Paso Robles, CA  
Tertiary Treatment Facilities Project  
CONTRACT NO. 16-22

## ADDENDUM NO. 1

March 17, 2017

6. Drawing CY503

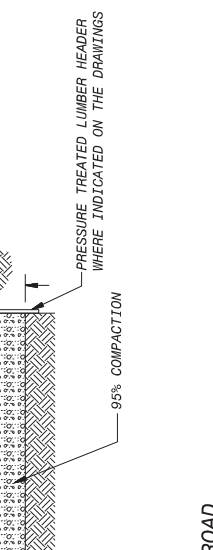
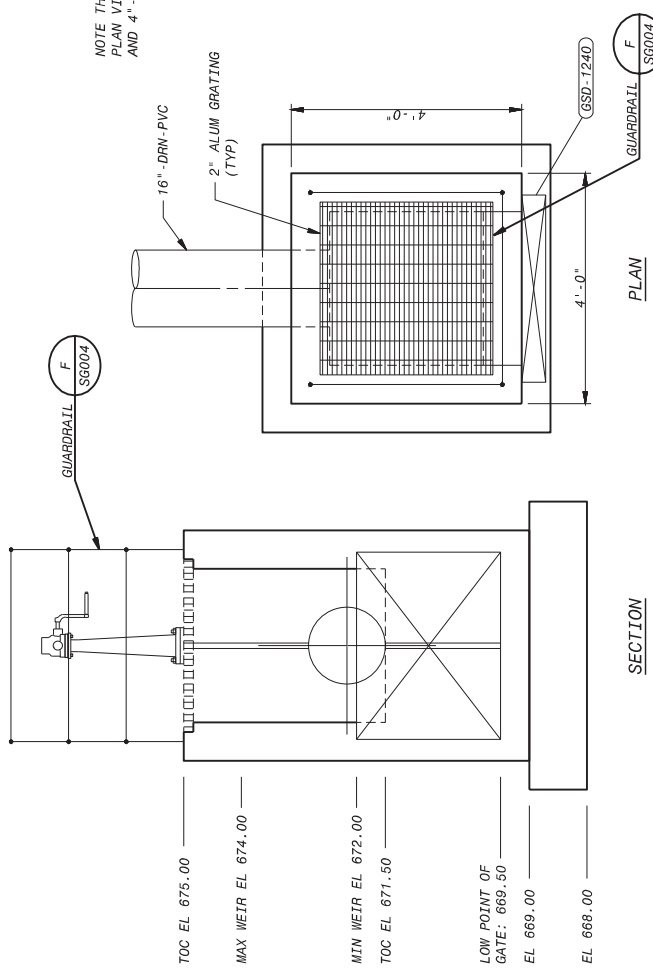
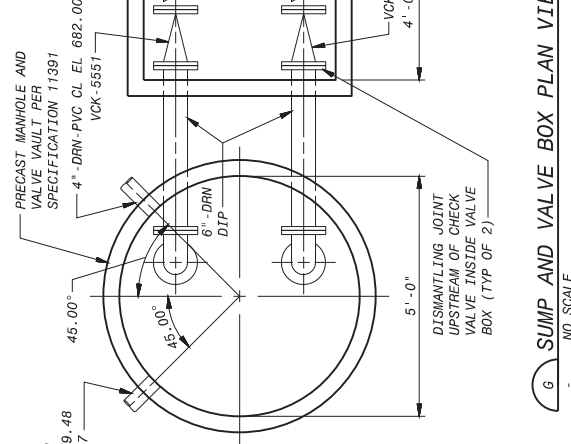
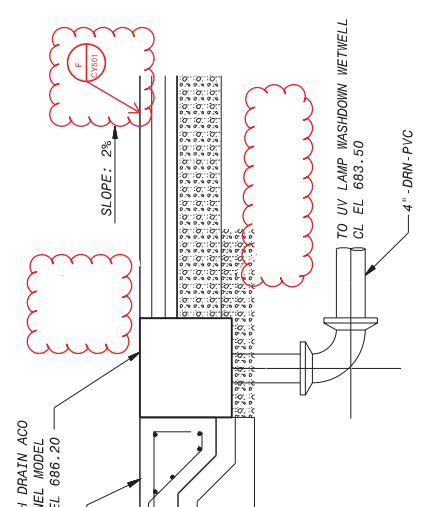
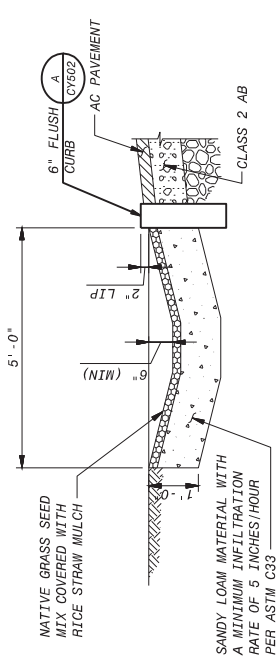
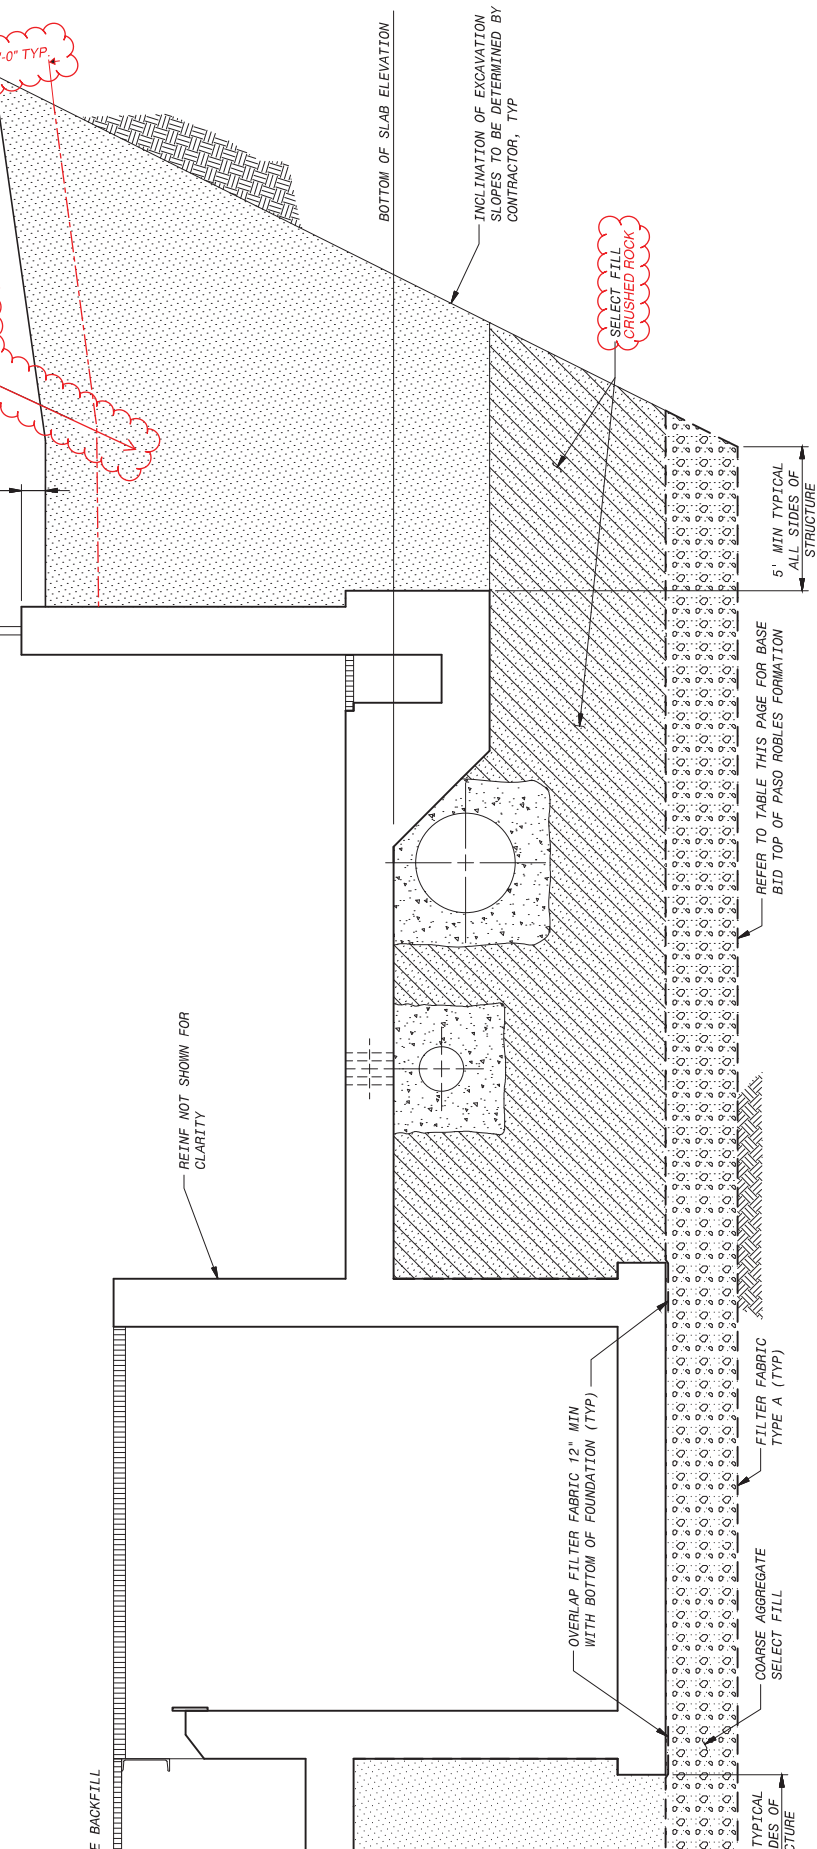
See Figure 1 attached.

SECTION 2  
 SF101 1/2" = 1'-0"

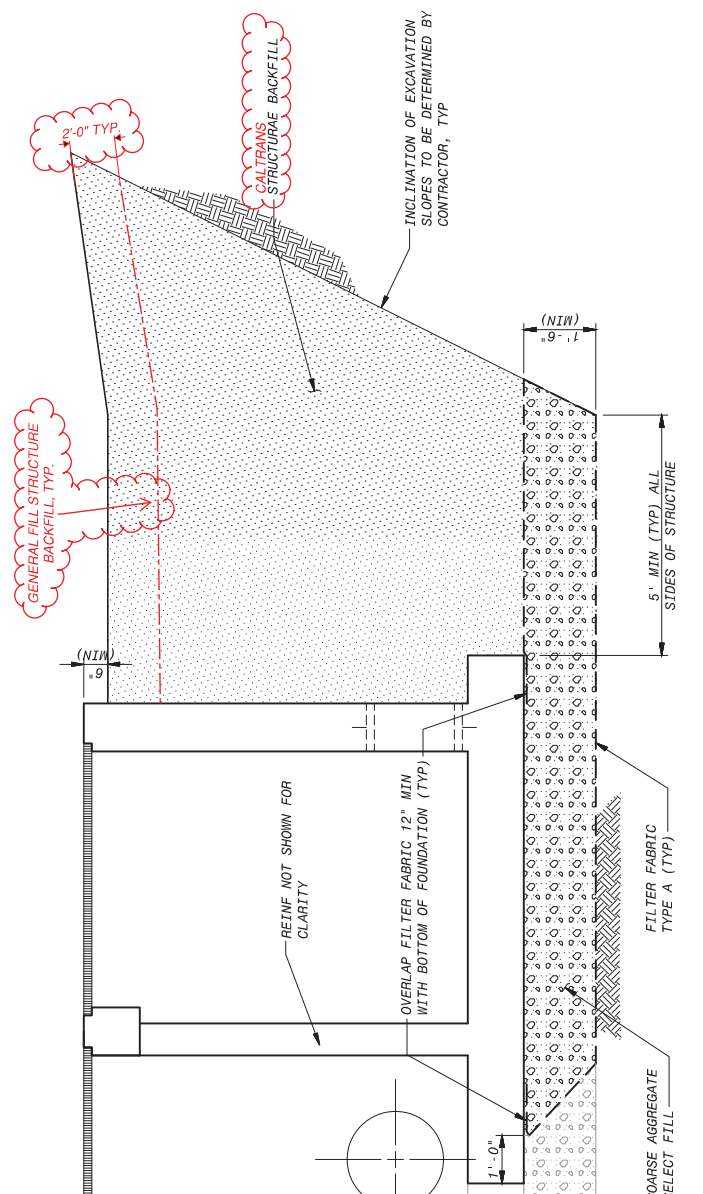
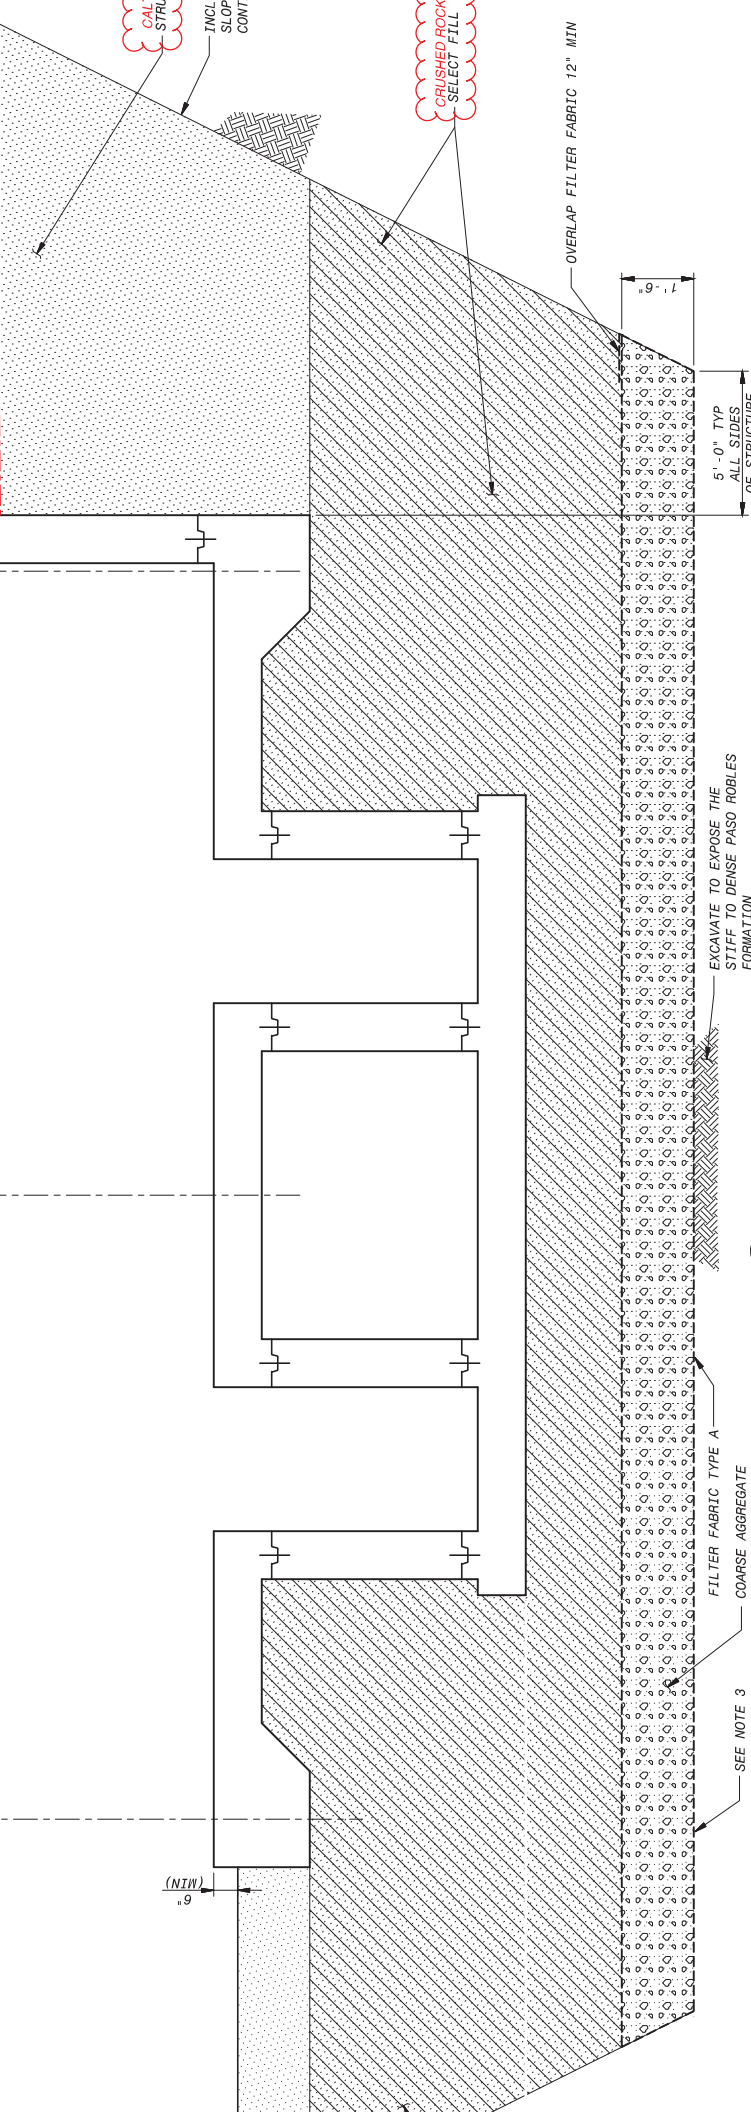
See Figure 2 attached.

NOTE:  
 1. OWNER'S INDEPENDENT TESTING OF EXPOSED MATERIALS TO DETERMINE SUITABILITY OF SUBGRADE SHALL BE REQUIRED. SEE SECTION 02200.

**SECTION 3**  
 SUT01 1/2" = 1'-0"  
 (UV BUILDING)

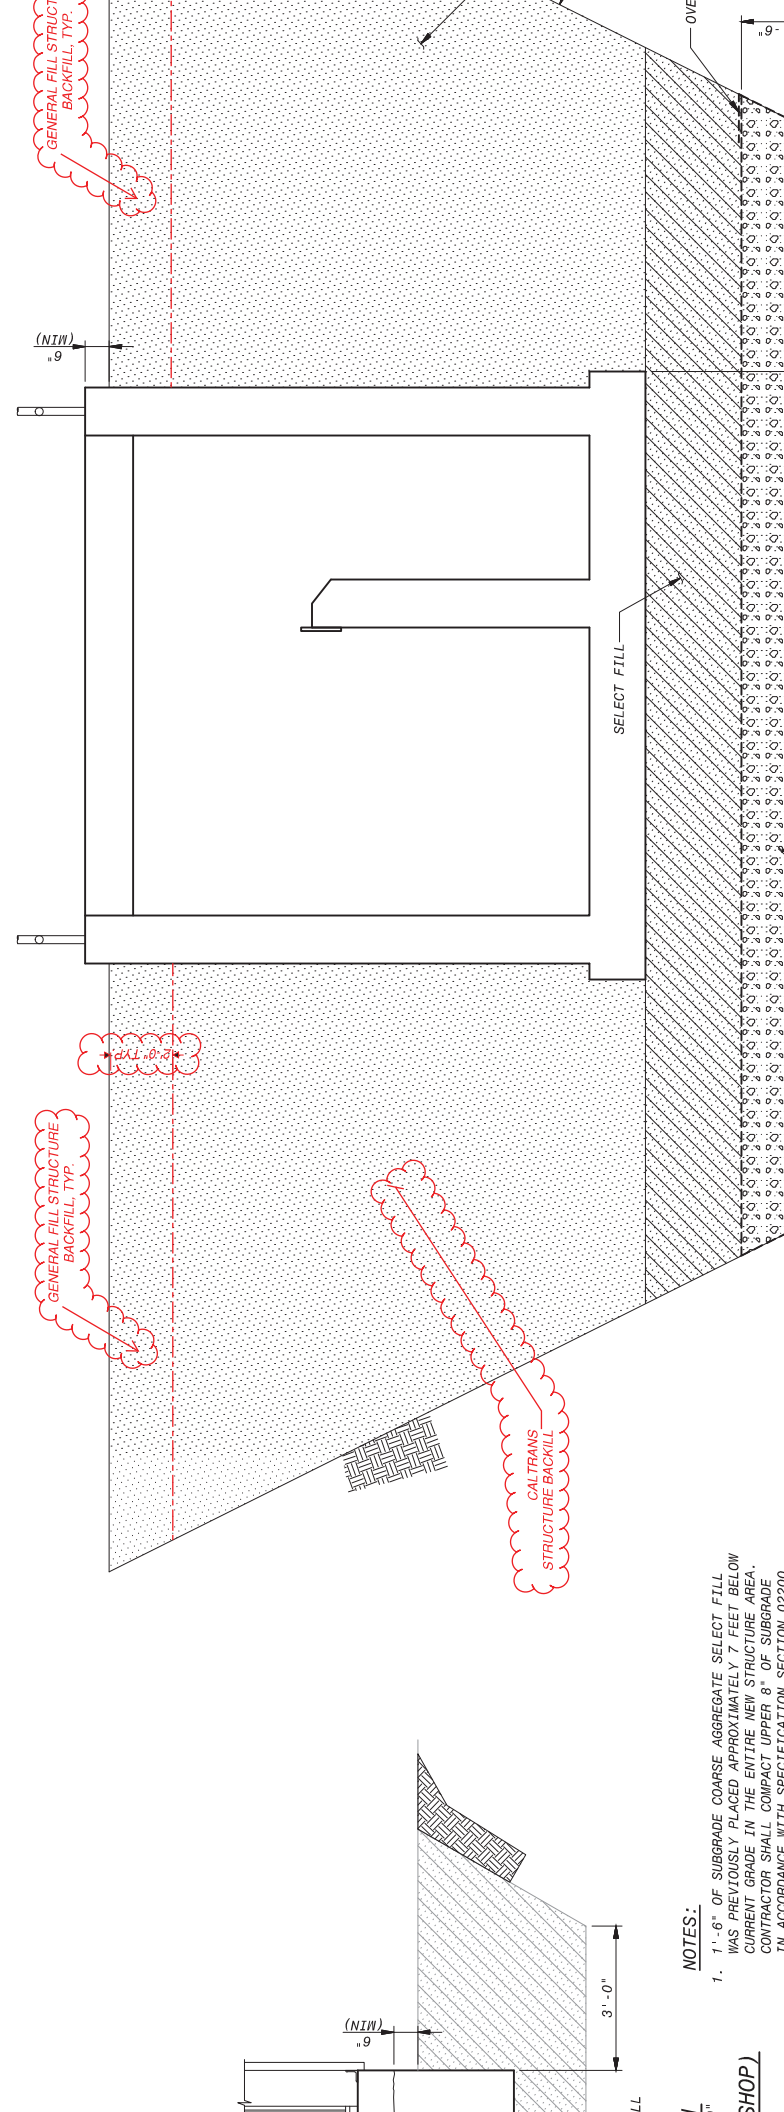
See Figure 3 attached.

- NOTES:**
- 1'-6" OF SUBGRADE COARSE AGGREGATE SELECT FILL WAS PREVIOUSLY PLACED APPROXIMATELY 7 FEET BELOW CURRENT GRADE IN THE ENTIRE NEW STRUCTURE AREA. CONTRACTOR SHALL COMPACT UPPER 8" OF SUBGRADE IN ACCORDANCE WITH SPECIFICATION SECTION 02200
